South Texas Project  
Units 3 and 4  
Docket Nos. 52-012 and 52-013  
Supplemental Response to Request for Additional Information

RAI 03.07.01-27, Supplement 4

**RAI 03.07.01-27, Supplement 4****QUESTION:****Follow-up Question to RAI 03.07.01-19 (STP-NRC-100093)**

**Figure 3H.6-212: Lateral Seismic Soil Pressure (psf) on RSW Piping Tunnel East Wall  
(Main Cross Section of RSW Piping Tunnel)**

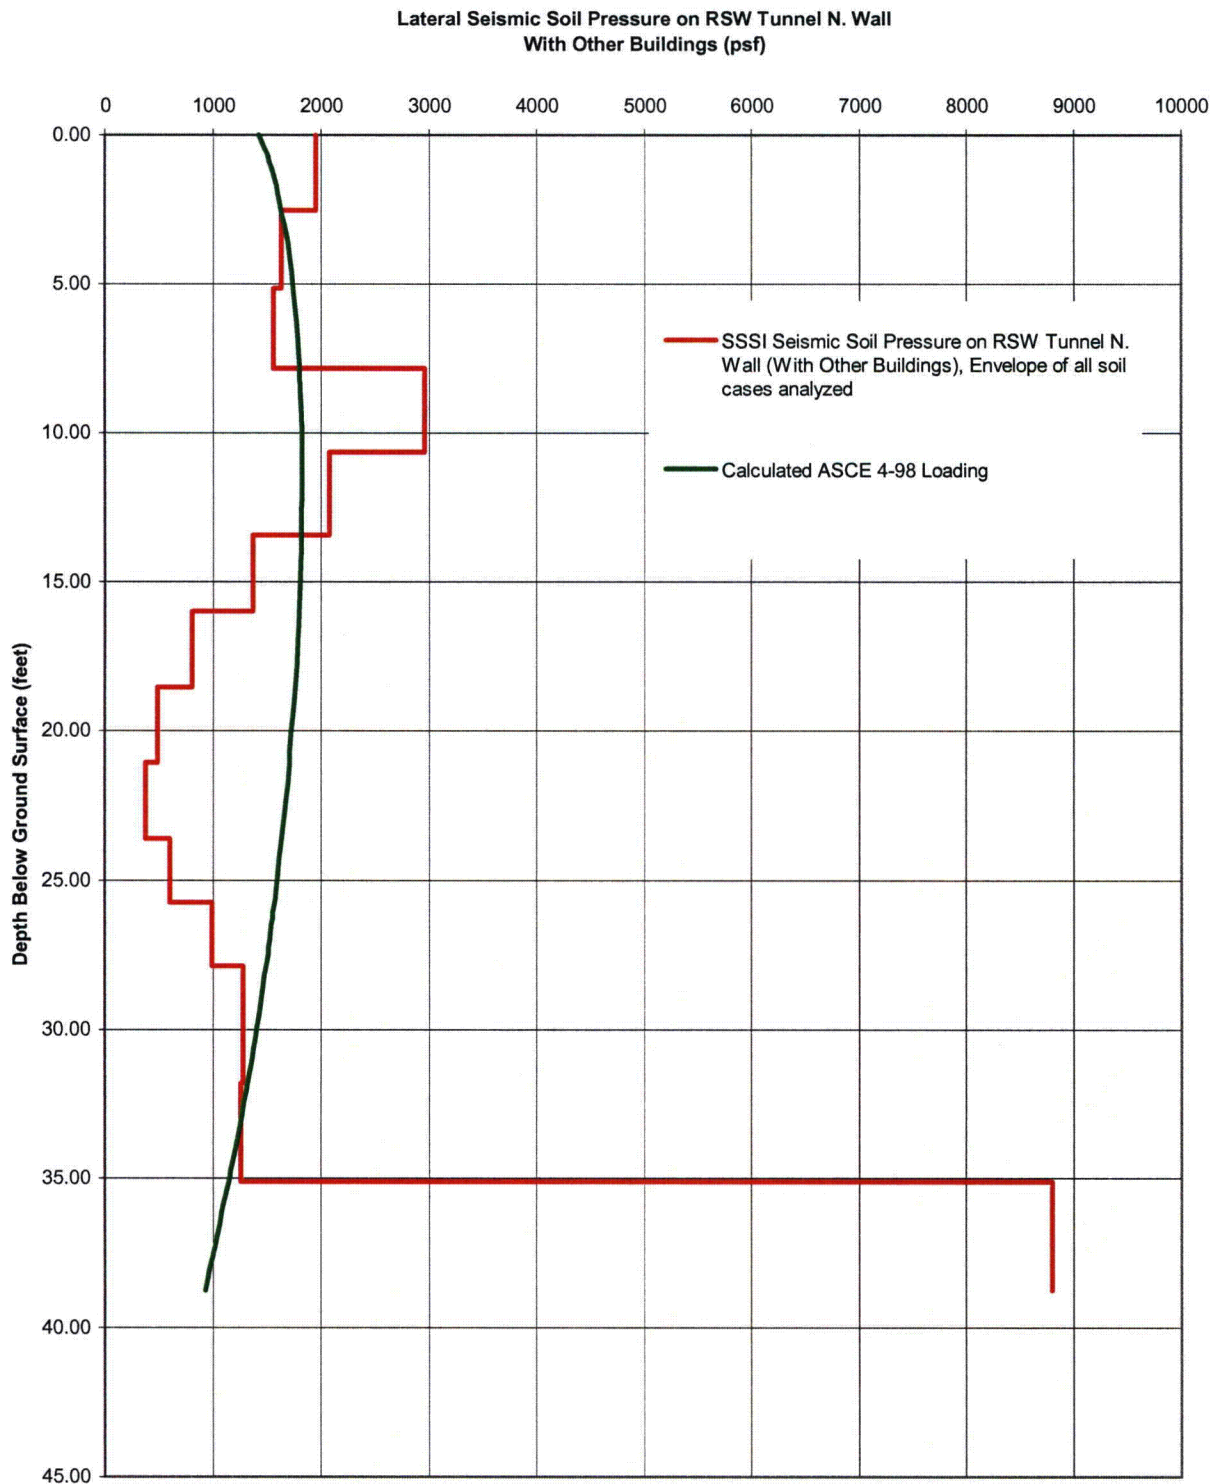
- b. *The COLA will be revised to refer to Figures 3H.6-212 through 3H.6-217 for RSW Piping Tunnel design (Audit Action Item 3.8-32, Punch List Item 80)*

See COLA mark-up for Section 3H.6.4.3.3 shown in the Enclosure. Also included in the Enclosure are additional clarifications for Sections 3H.6.2, 3H.6.4.3.1.4 and 3H.7.4.3.1.3.

Figure 3H.6-218: SSI, SSSI, ASCE 4-98 and Design Lateral Seismic Soil Pressures on RSW Pump House South Wall

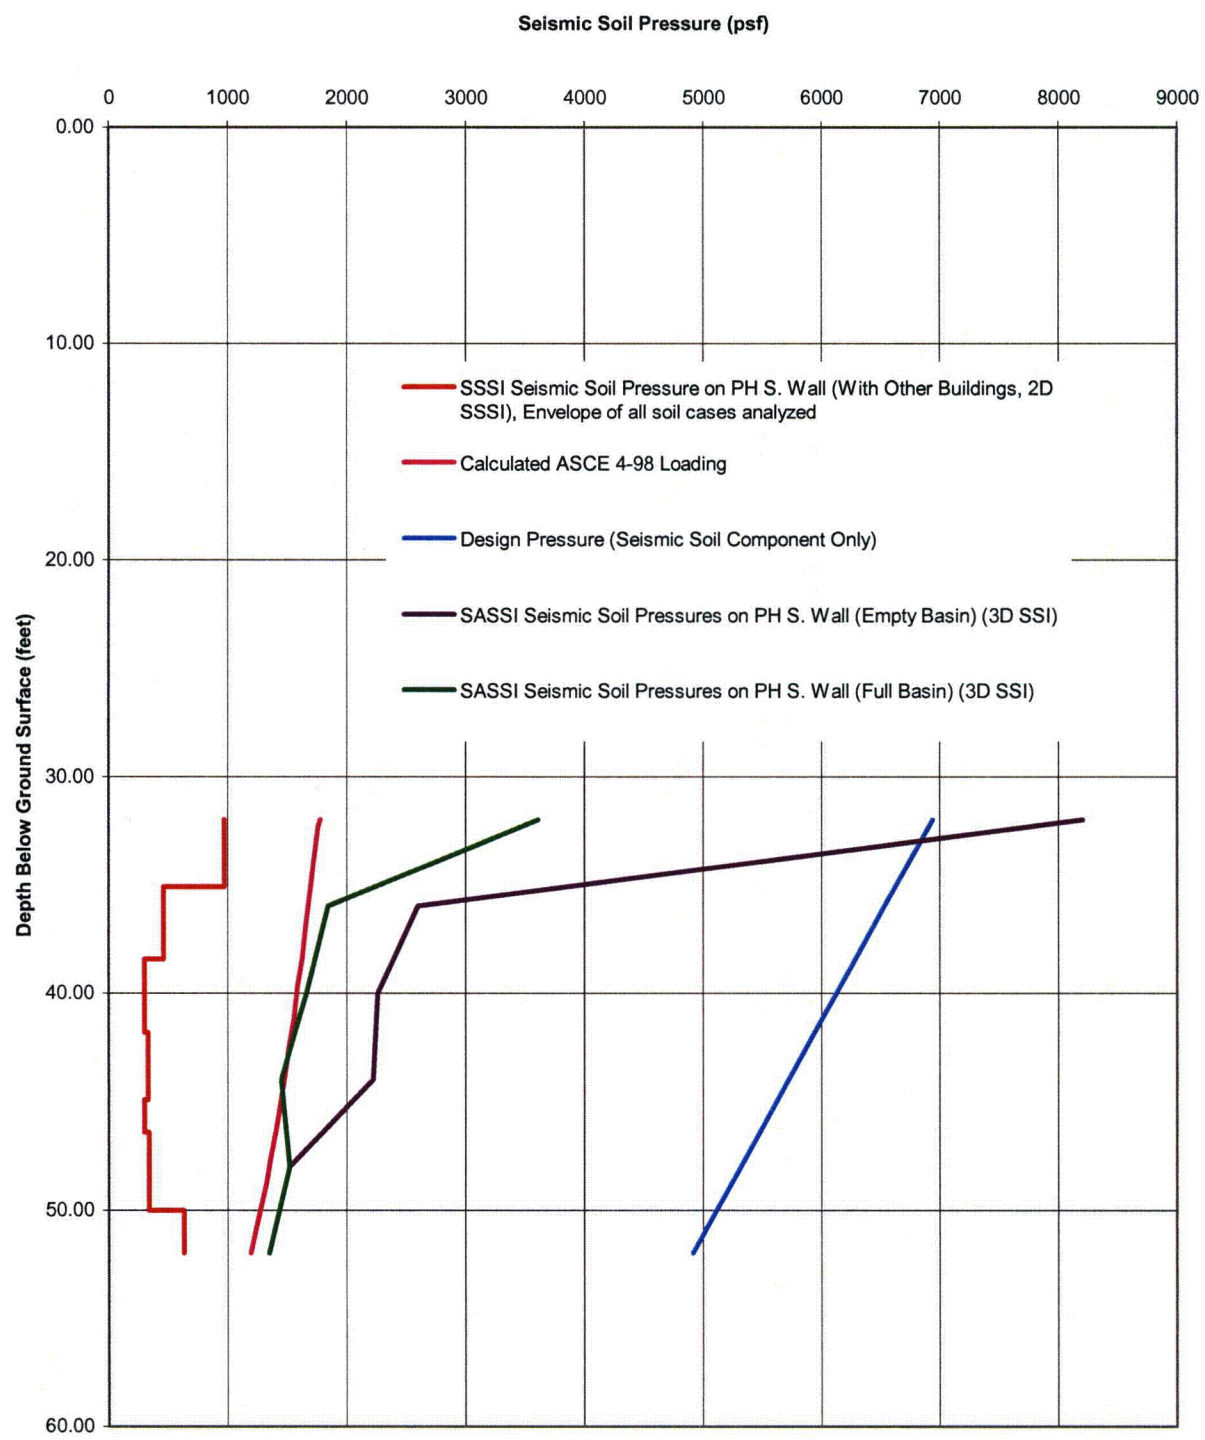
- c. *Revise Figure 3H.6-219 to remove 2D 'Alone' soil pressure profile. Also revise the figure to provide seismic pressure profile used for design in lieu of static + dynamic. Also check other figures for the same issues (Audit Action Item 3.7-42, Punch List Item 87)*

See revised soil pressure figures provided in the Enclosure. These revised figures replace the previous figures (with the same figure numbers) in entirety.
